Staff Report BZA23-002-VA

Blue Beacon Parking | Color | Landscaping

Meeting Date: May 4, 2023

Docket BZA23-002-VA Blue Beacon Parking, Color, and Landscaping Variances. The applicant is requesting four Variances to construct an approximate 14,871 square foot truck wash use on the northeast side of Indianapolis Road. The applicant is proposing (1) 42 parking stalls where the maximum is 14.8; (2) using a bright color as a primary façade color rather than an accent; (3) plantings street trees further than 25 feet from the right-of-way; and, (4) relocating bufferyard plantings to other locations on site. The applicant is Blue Beacon International, Inc. on behalf of the owner Whitestown Crossing, LLC.

Exhibit A
N.T.S.

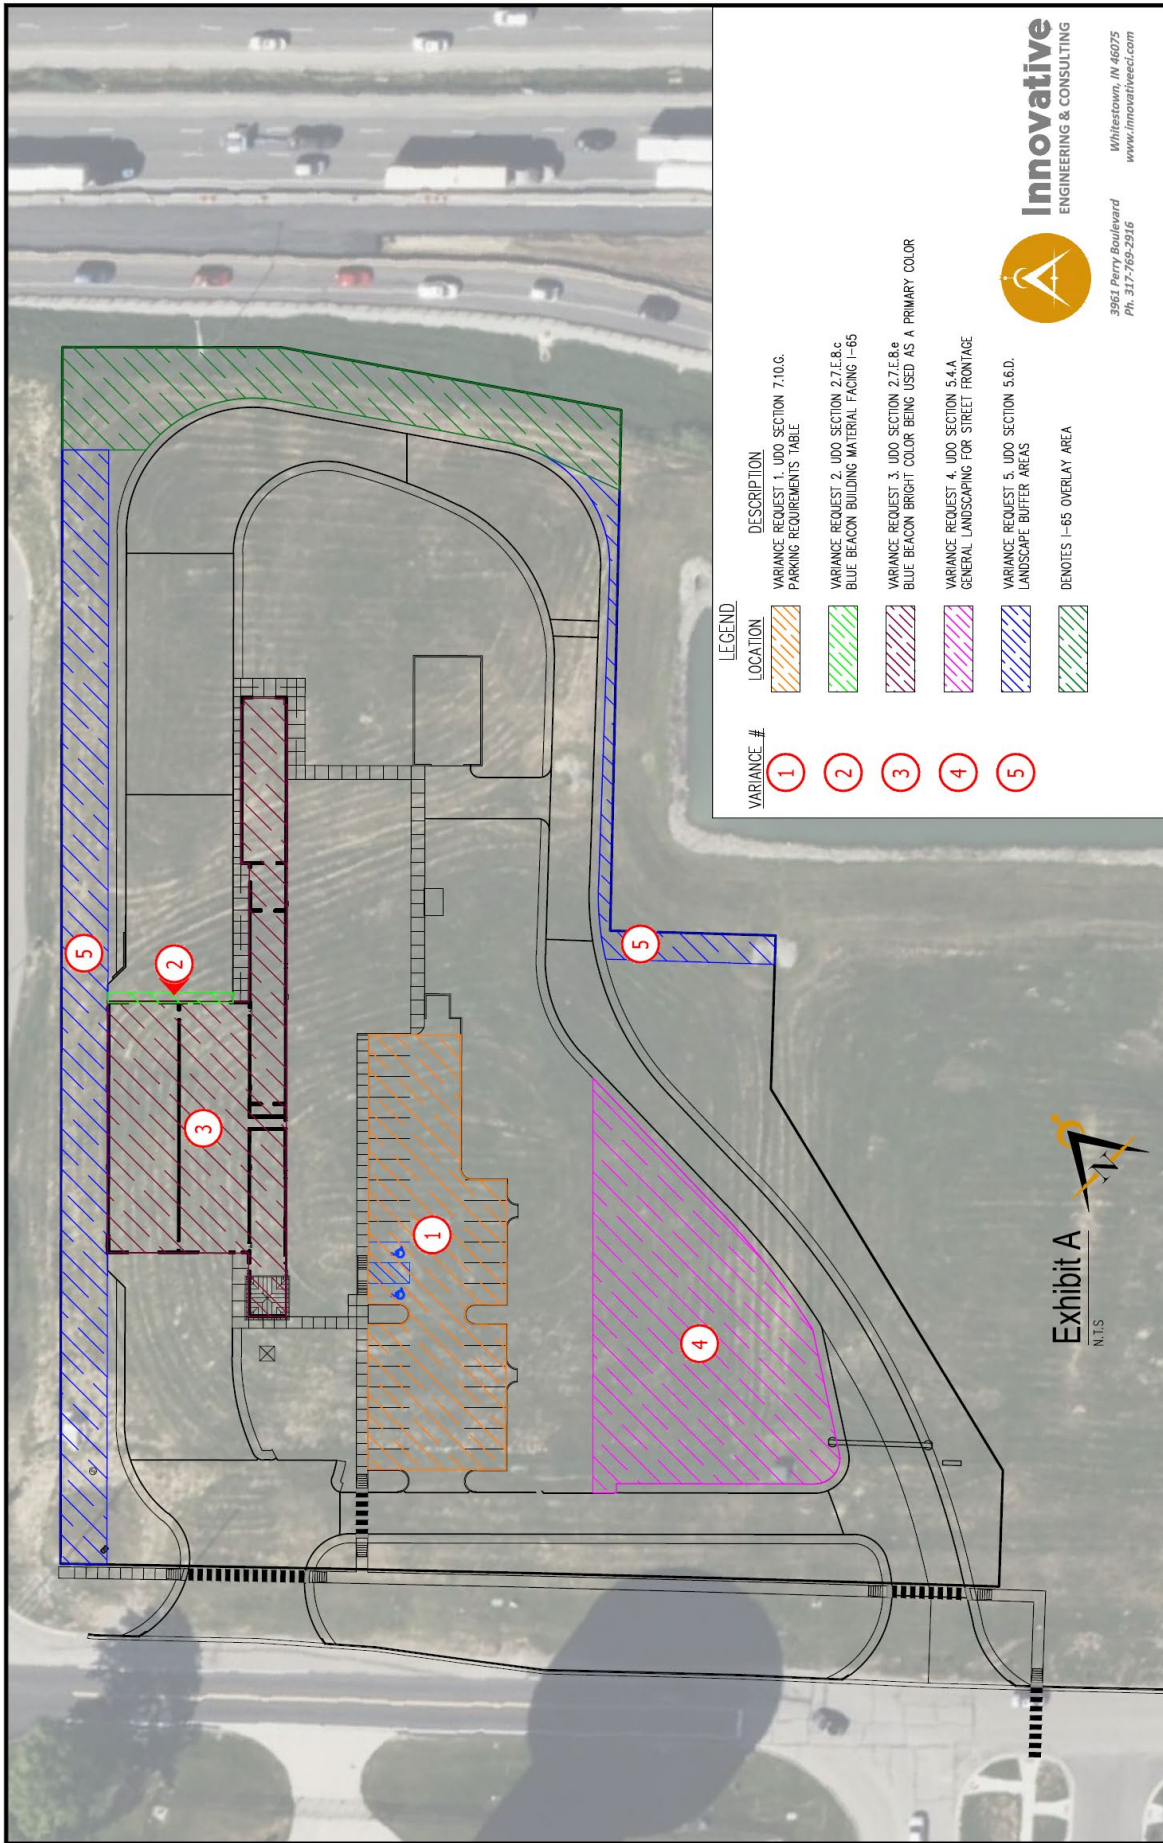
The maximum number of standard parking stalls based on the square footage of the structure is 14.8 stalls. The applicant is proposing 42 parking stalls.

The applicant is proposing to plant the required street trees along Indianapolis Road a distance of greater than 25

The applicant is required to provide the buffer to the north adjacent to Timpte. The applicant is proposing to relocate some of the required plantings to other locations on site.

Staff is providing a favorable recommendation for the Blue Beacon parking Variance docket BZA23-002-VA.

Staff is providing a favorable recommendation for the Blue Beacon street frontage tree planting Variance docket BZA23-002-VA.

Staff is providing a favorable recommendation for the Blue Beacon northern landscape buffer Variance docket BZA23-002-VA.

**NORTH ELEVATION
Exhibit B
N.T.S.**

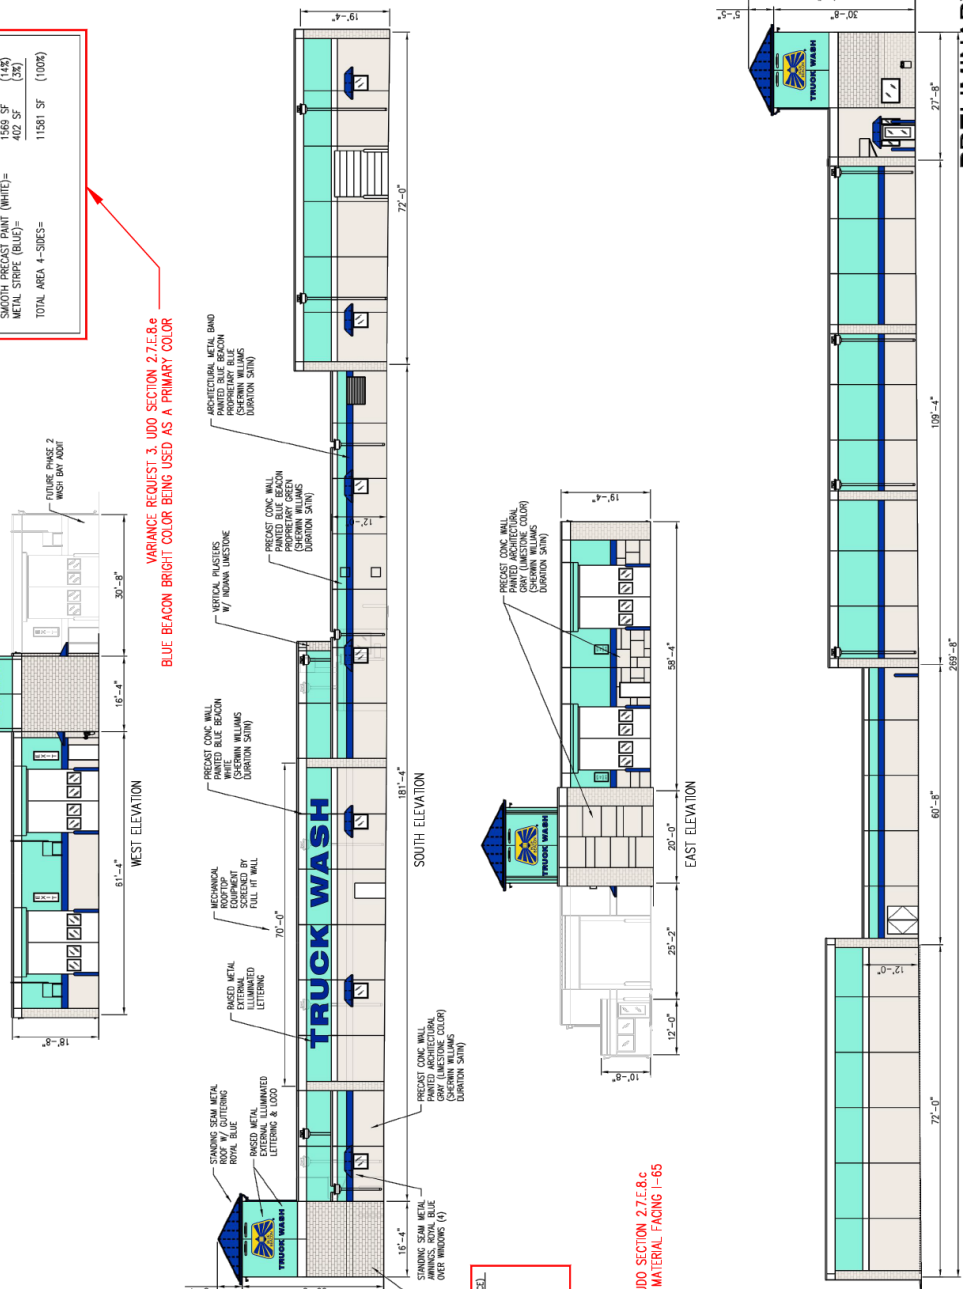
The applicant is using a bright color known as 'BBI green' as a primary façade color rather than an accent.

Staff is providing an unfavorable recommendation for the Blue Beacon bright color being used as a primary color Variance docket BZA23-002-VA.

1. The approval will be injurious to the public health, safety, morals, and general welfare of the community because:
Approval of the variance will be injurious to the public health, safety, morals, and the general welfare because the quantity of bright color may be an unsafe distraction to drivers traversing through the community. The intent is to capture truck driver's attention but it may also distract truck and non-truck drivers because it is not a muted color.

3. The strict application of the terms of the Ordinance does not result in practical difficulties as applied to the property for which the variance is sought because:
The strict application of the ordinance does not result in practical difficulties because the desire for the BBI Green color is a desire of the applicant. The site faces no physical or peculiar conditions that would require the building to utilize an accent color as a primary color. While the UDO does not define what an accent color is, under the Legacy Core District an accent color is noted as a maximum of 10% of the building façade.

If the Board of Zoning Appeals approves Variance Request 2, staff recommends either placing a maximum percentage of BBI Green color that is permitted on each façade or the Board can approve the elevations as presented.
